# BORREGO VALLEY GROUNDWATER SUSTAINABILITY AGENCY

Under the Sustainable Groundwater Management Act (SGMA), the County of San Diego (County) and Borrego Water District (BWD), as the Groundwater Sustainability Agency (GSA) for the Borrego Springs Groundwater Subbasin (Subbasin), has solicited and responded to comments from the public and from other agencies concerned with the Draft Groundwater Sustainability Plan (GSP). The Draft GSP was made available by the GSA for public review on March 22, 2019. The public comment period for the Draft GSP ended on May 21, 2019. Agencies, organizations, and individuals submitting comments on the plan are listed below, organized by category.

**Subject: Comments on the Draft Borrego Valley Groundwater Basin Groundwater Sustainability Plan**

Figure 1. Landsat satellite data from GDE Pulse<sup>2</sup> of the Mesquite (*Prosopis glandulosa*) vegetation mapped within GDE Unit 3, and groundwater levels from nearby MW-5B.

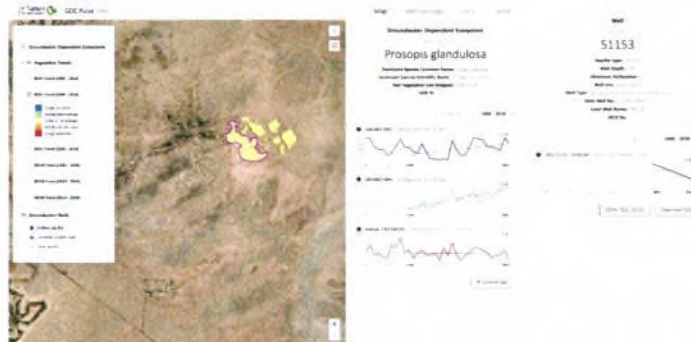
- There is insufficient evidence to conclude that current groundwater levels are no longer supporting the honey mesquite. The Mesquite polygons in the NC dataset were mapped from 1996, however, 35 years of Landsat imagery<sup>6</sup> (Figure 1) show a slight upward trend in vegetation growth (indicated by Normalized Vegetation Difference Index (NDVI)) and leaf moisture (indicated by Normalized Vegetation Moisture Index (NDMI)), with fluctuations over wet and dry years during this time period. Scientific studies<sup>7,8,9</sup> have found that gradual increases in depth to groundwater within a GDE with historically shallow groundwater levels tends to result in an altered species composition due to the migration of more opportunistic invasive species that have deeper rooting systems and are better adapted to deeper groundwater conditions. Please conduct field verification to determine whether the polygons in this area are still Mesquite or if the invasive Tamarix (e.g., *Tamarix ramosissima*) is prevalent. If either are present, it is still very likely that groundwater is currently supporting these phreatophytes. However, the presence of Tamarix and the lack of Mesquite would likely suggest that pre-SGMA adverse impacts are underway, confirming previous observations. If this is the case, conservation efforts (removal of *Tamarix* spp.) could provide water supply benefits for the Borrego springs area and the Mesquite vegetation. Visit TNC’s Groundwater Resource Hub for a case study on how the invasive *Arundo donax* is being removed in Ventura County to improve groundwater supply and enhance habitat<sup>10</sup>.

**Figure 2. Figure 3.3-2 is annotated to demonstrate how the proposed pumping restrictions permit groundwater conditions to worsen post-2015 in the basin.**

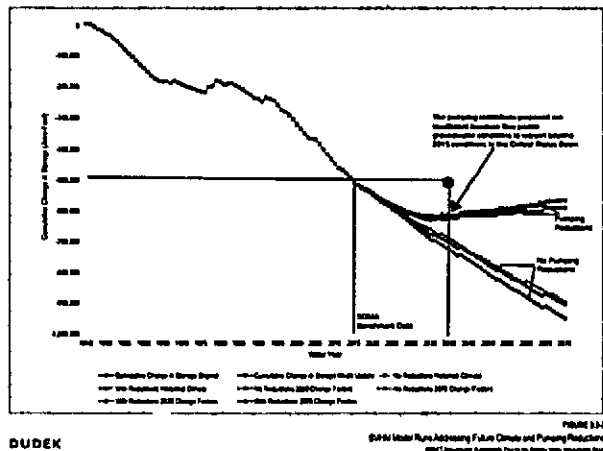
- o The target sustainable yield of 5,700 AFY does not take climate change into consideration, and establishing a target sustainable yield based on historical climate conditions fails to sustainably manage groundwater resources for current and future social, economic, and environmental benefits, thus deviating from the legal intent of SGMA. SGMA was passed at the height of California's historic drought, a period of time that was characterized by adverse impacts to domestic well owners (e.g., dry wells), GDEs (e.g., water stress impacts on growth, reproduction, and even mortality due to lack of groundwater), and surface water users (e.g., lower streamflows). Critically overdrafted basins, such as the Borrego Valley Basin, are more likely to have disproportionately experienced these adverse impacts due to historical groundwater overdraft in the basin.

- o As currently written in the GSP, a sustainable yield target of 5,700 AFT results in pumping restrictions that permit groundwater conditions to worsen by ~100,000 AF beyond 2015 conditions (see Figure 2 in this letter). This has resulted in the groundwater level measurable objectives and interim milestones in Table 3-7 to be deeper than they are in 2018. This is highly problematic, given that Borrego Valley has been characterized as a critical status basin nor does it adequately prevent adverse impacts to beneficial users in the basin.
